CONSTRUCTION PLANS FOR LORSON RANCH EAST

EAST JIMMY CAMP INTERCEPTOR SANITARY SEWER CONSTRUCTION PLANS

Markup Summary

SHEET NUMBER
C1.1

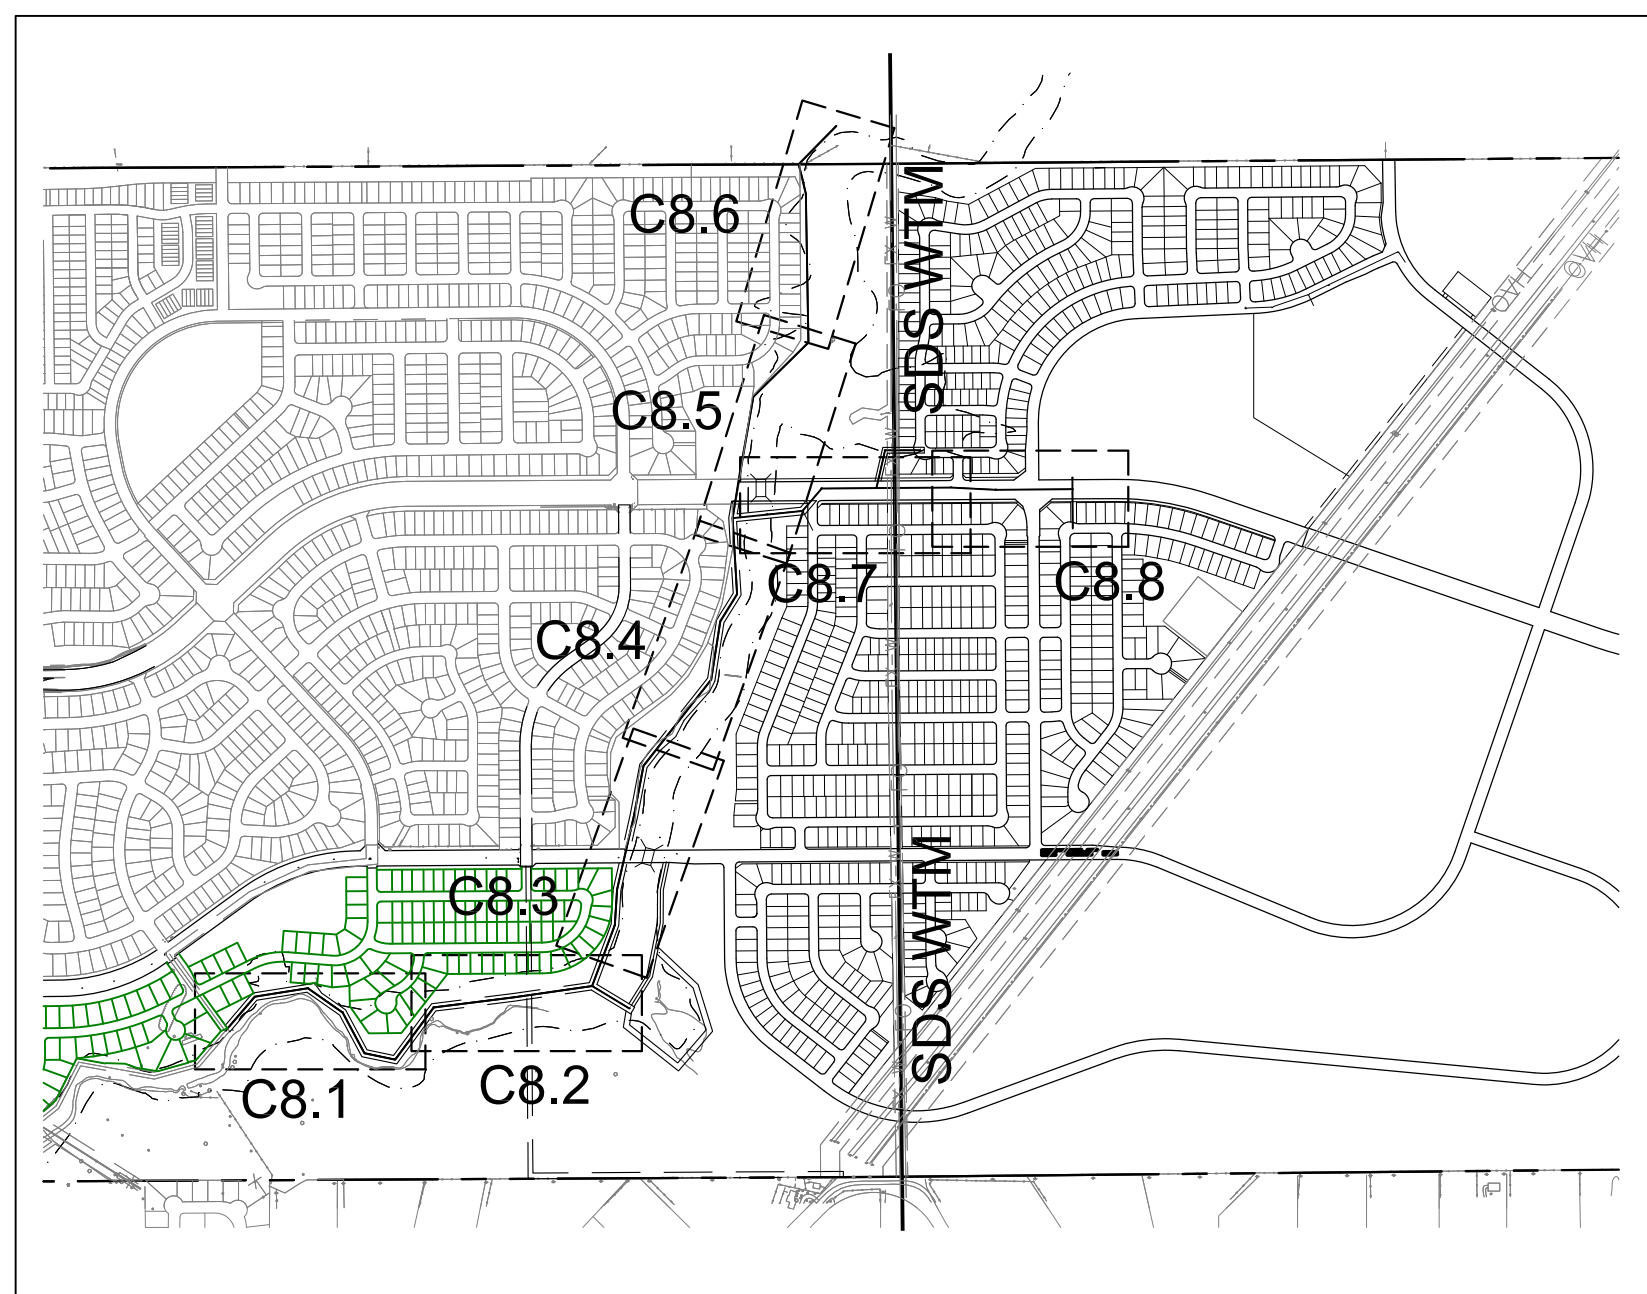
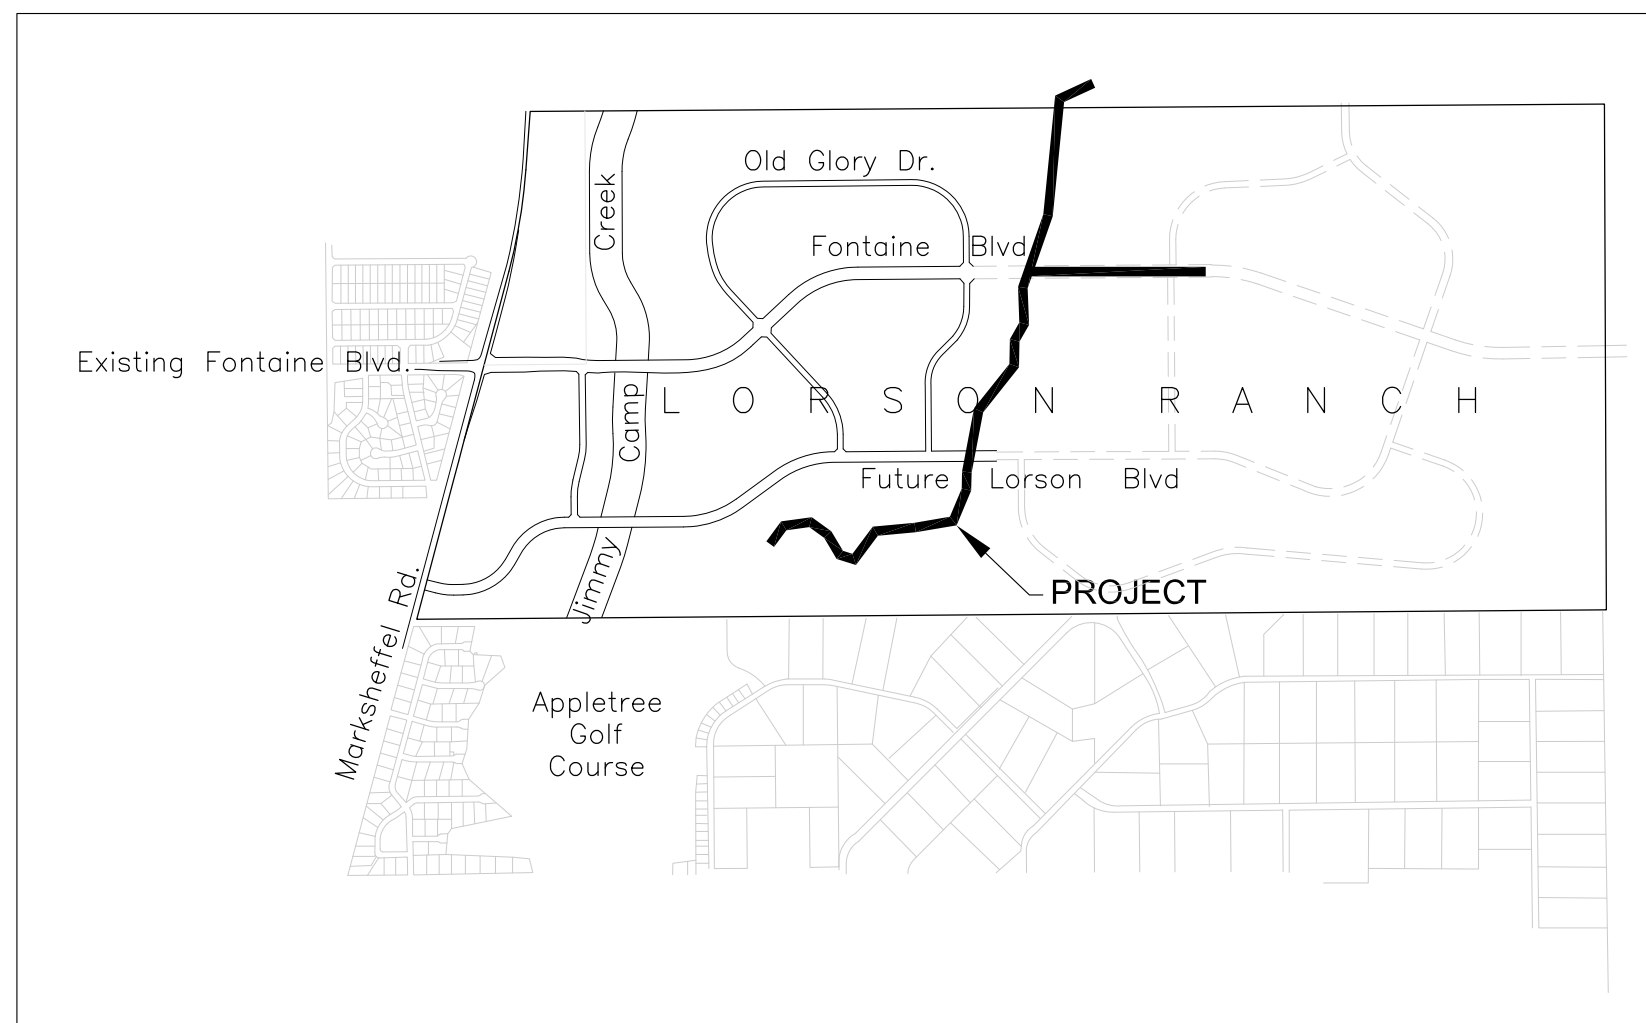
Provide a GEC details sheet

SHEET NUMBER: **C4.1**

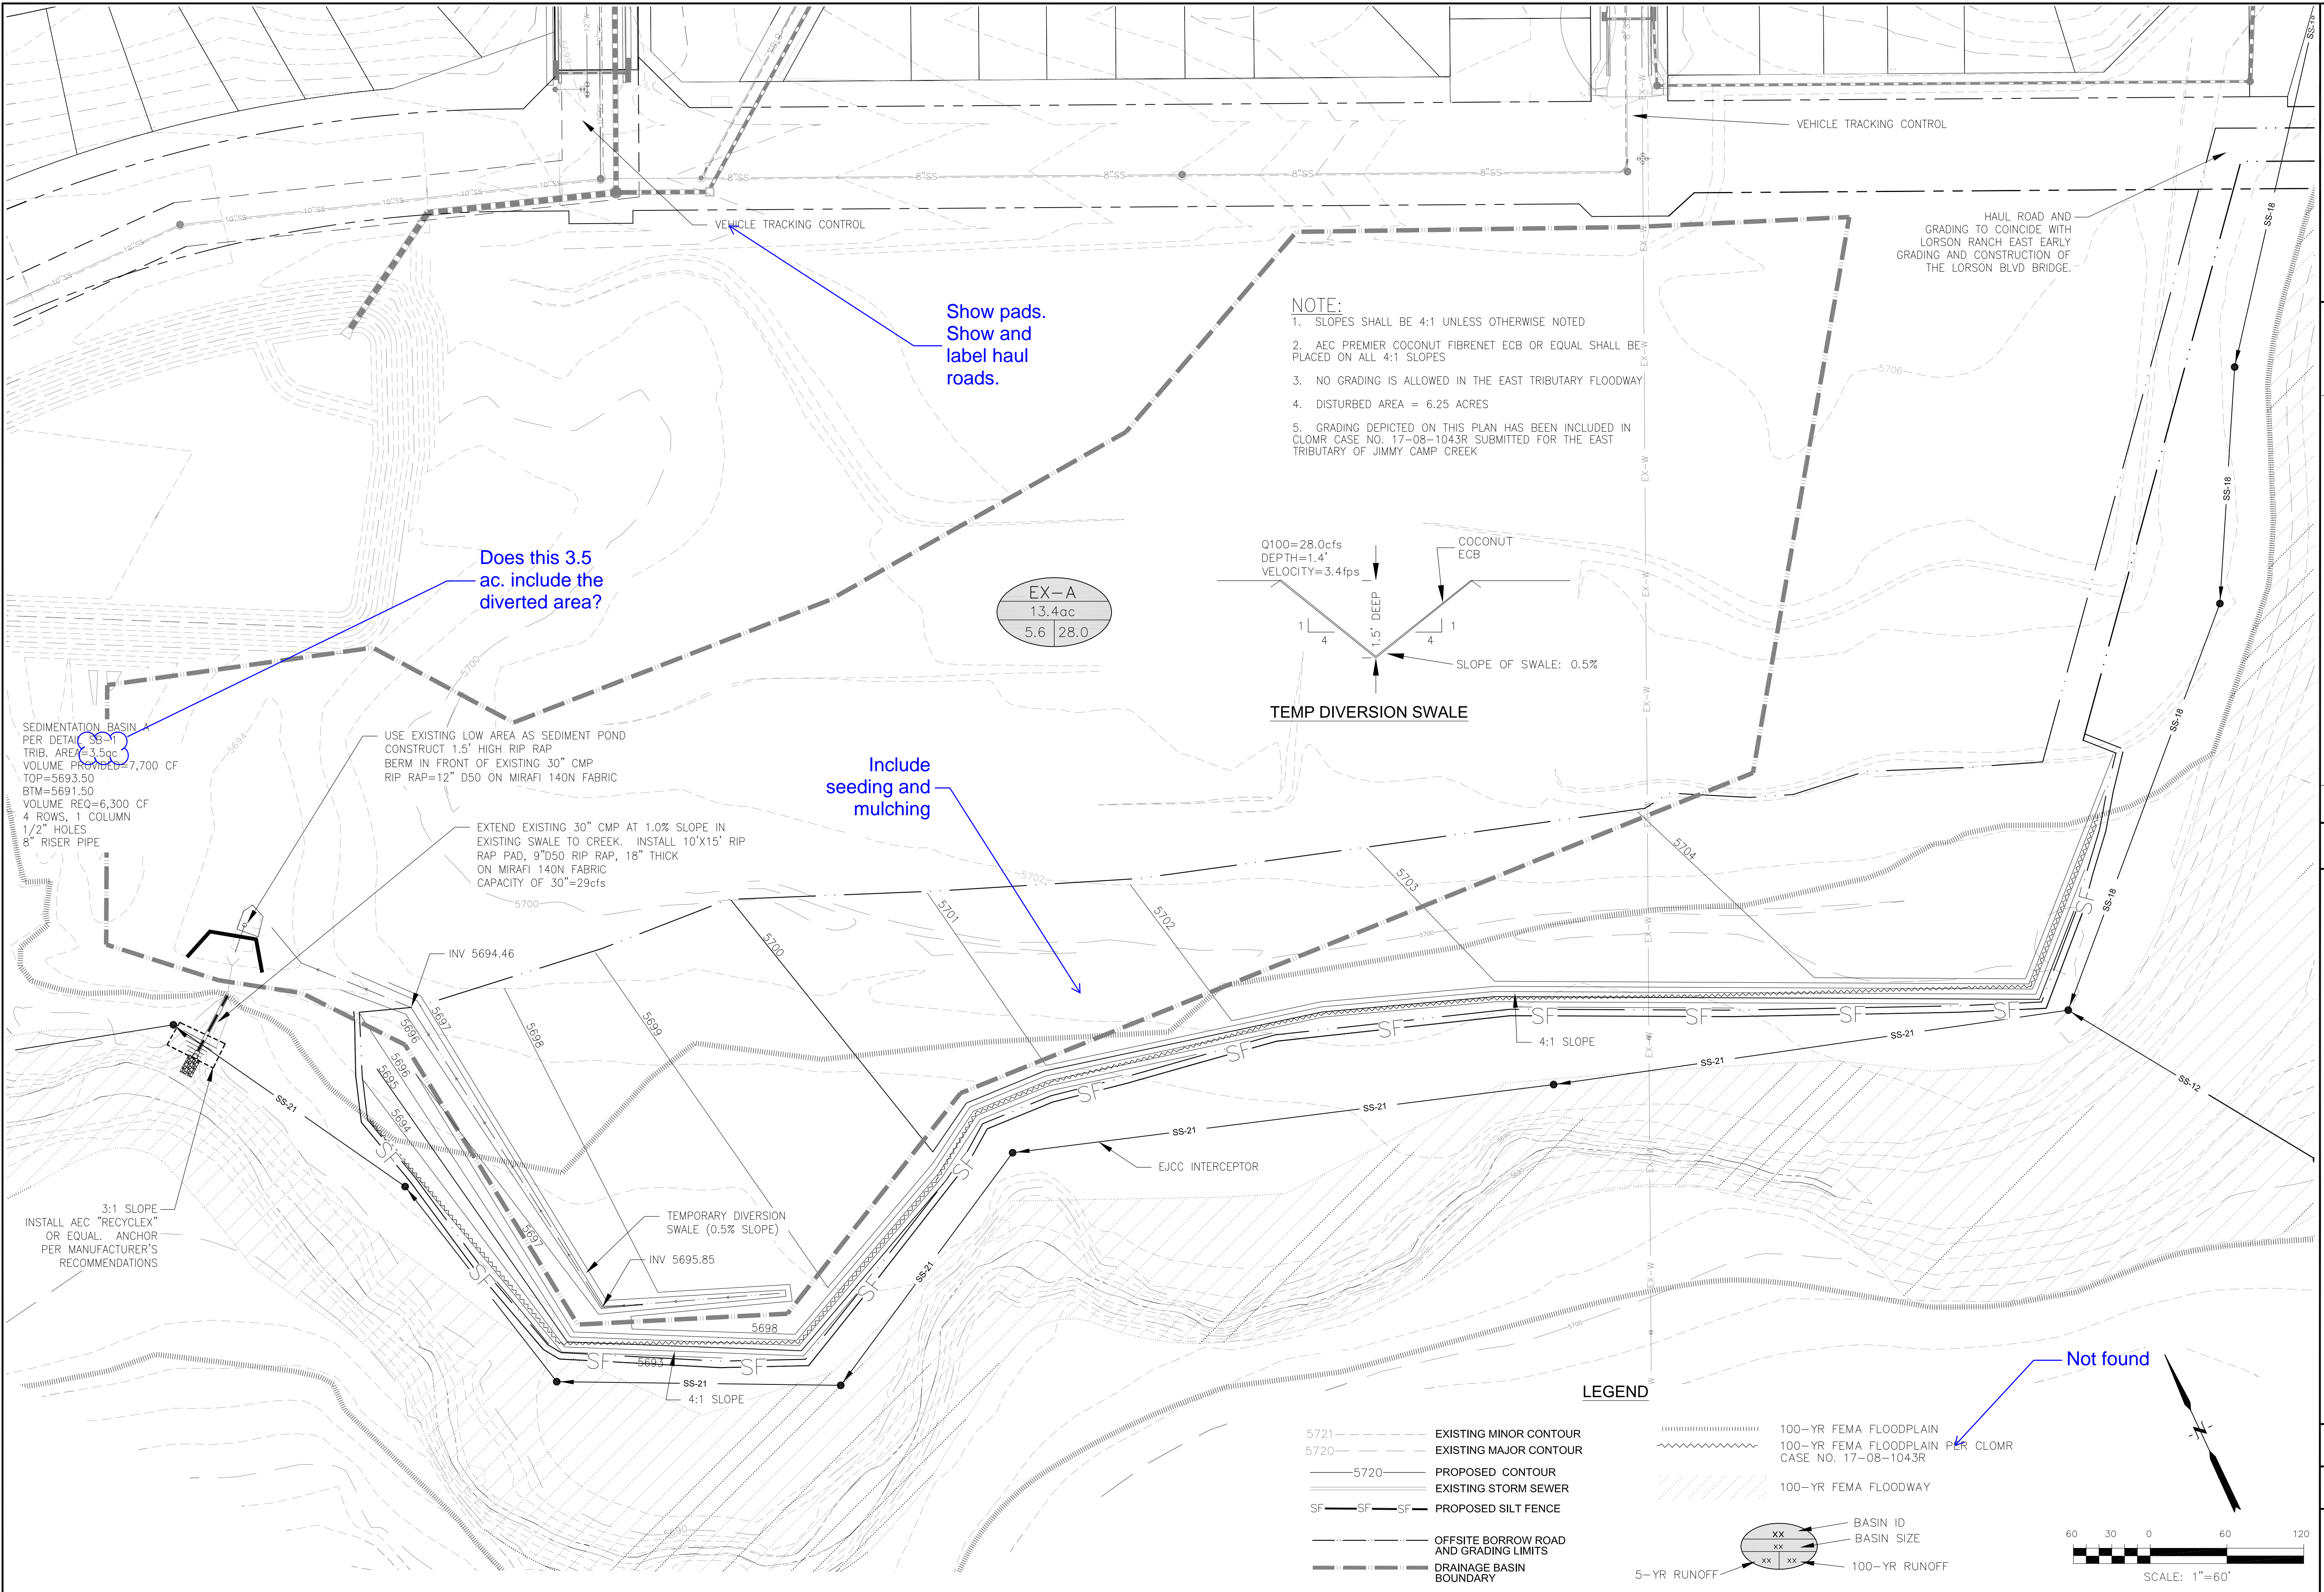
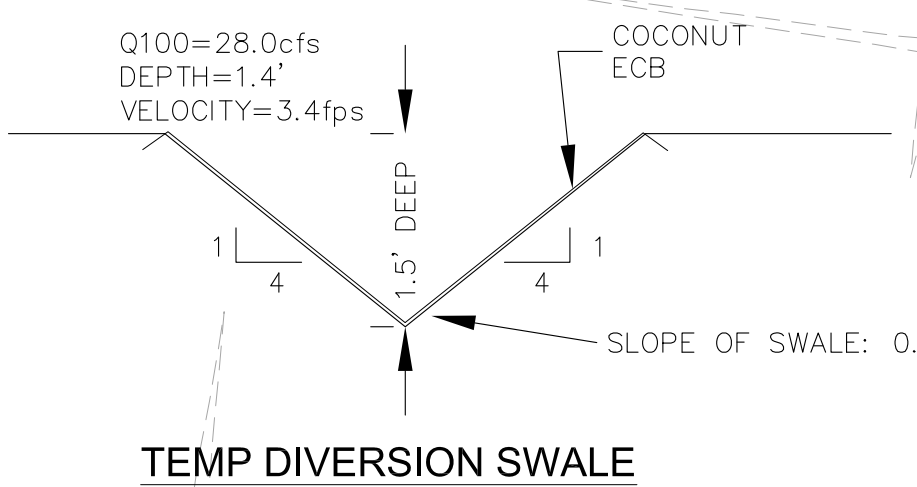
Show pads. Show and label haul roads.

Include seeding and mulching

Does this 3.5 ac. include the diverted area?

SHEET NUMBER
C8.2

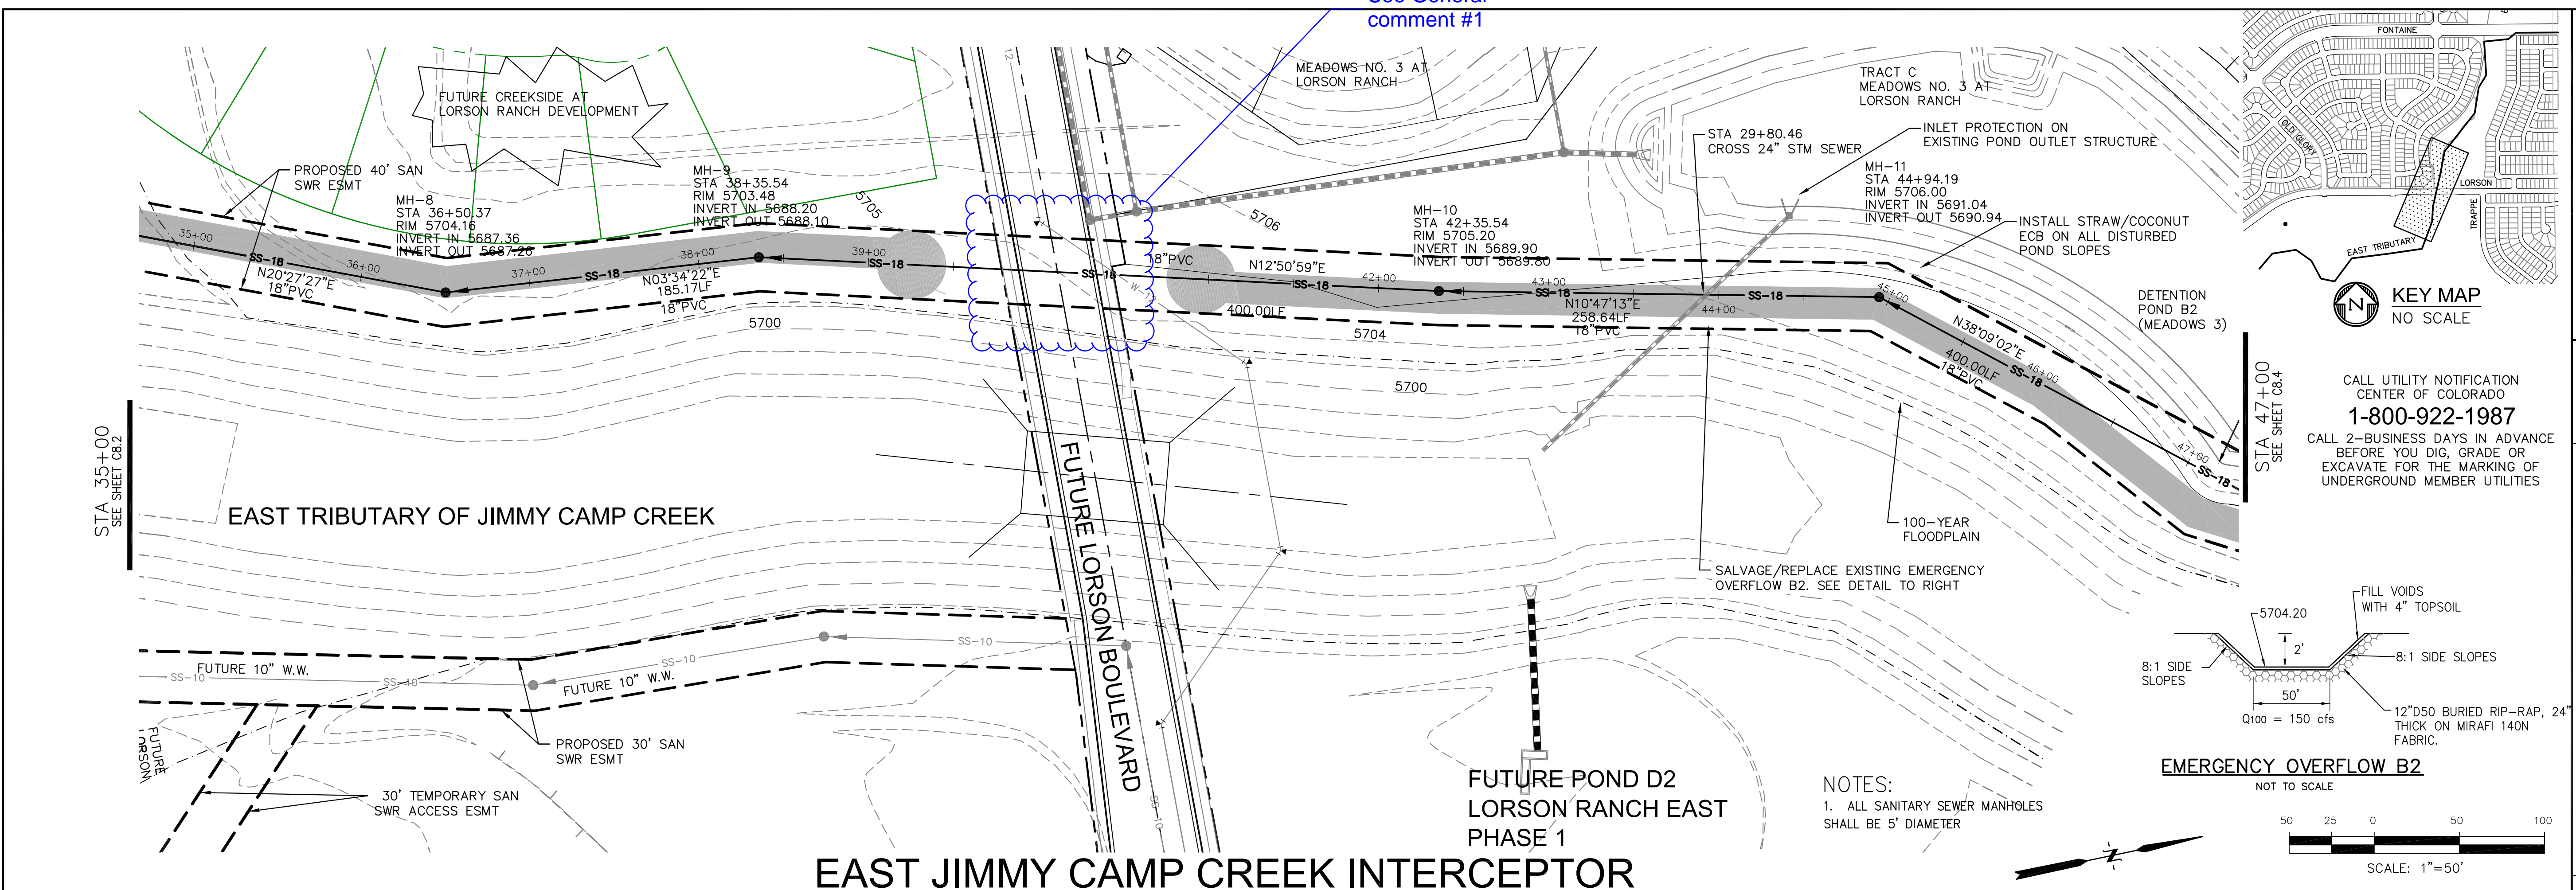
See General comment #1
